RE: Sydney Metro Central Tunnelling Package: Visual Amenity Management Plan (Rev 7)

As the approved Environmental Representative for the Metro West and as required by Conditions A30(j) and C1, following review of the document the VAMP Rev 7 is endorsed.

Visual Amenity Management Plan

Sydney Metro West – Central Tunnelling Package

SYDNEY METRO WEST VISUAL AMENITY ASSESSMENT	
THE BAYS STATION - RECOMMENDATIONS	
STATUS: ECI DESIGN	SHEET 01 OF 01
Dwg No. SMW-AFJV-SLY-DWG-605500	REV.

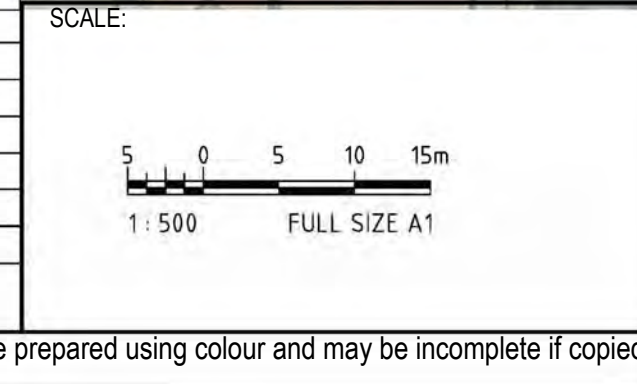
THE BAYS STATION	
POTENTIAL IMPACTS	RECOMMENDATIONS/ COMMENTS
Acoustic shed	Consider a colour palette matching adjacent built form to aid visual integration
Robert Street	Retention of roadside vegetation and remnant walls on site periphery to provide visual screening
Highlighted area	Visual disturbance in this area will be notable from the Anzac Bridge approach shared path partially filtered by distance, level change and vegetation. Likely to be of interest from the elevated share path and would be seen within the context of the working port. No action needed
Sitewide	Proposed works in this area are in line with the industrial character and zoning. The scale of the proposed change is in keeping with existing adjacent built form within the port and along Robert Street. No action needed
Site wide	Consider proposed lighting schedule and intensity to be appropriate for roads, residential areas and other surroundings.

Potential Impacts	Recommendations/Comments	How addressed
The Bays		
Acoustic shed	Consider a colour palette matching adjacent built form to aid visual integration.	As described in Section 7.2 all sheds will be Mangrove in colour. This has been chosen as it is typically sympathetic to its surroundings.
Robert Street	Retention of roadside vegetation and remnant walls on site periphery to provide visual screening.	Removal of vegetation will be minimised to the greatest extent possible, consistent with measure FF09 of the Flora and Fauna Management Plan (FFMP).
Highlighted area	Visual disturbance in this area will be notable from the Anzac Bridge approach shared path partially filtered by distance, level change and vegetation. Likely to be of interest from the elevated share path and would be seen within the context of the working port. No action needed.	Noted
Sitewide	Proposed works in this area are in line with the industrial character and zoning. The scale of the proposed change is in keeping with existing adjacent built form within the port and along Robert Street. No action needed.	Noted

**SYDNEY METRO WEST - VISUAL AMENITY ASSESSMENT
 NORTH STRATHFIELD STATION - PROPOSED WORKS**

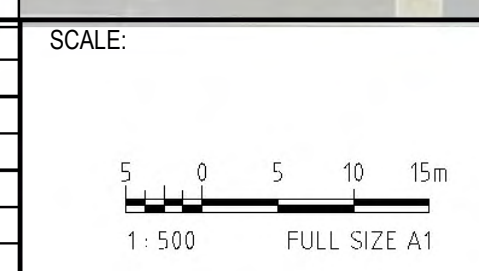
SITOWIDE: CONSIDER LIGHTING SCHEDULE AND INTENSITY TO BE APPROPRIATE FOR ROADS, RESIDENTIAL AREAS AND OTHER SURROUNDINGS
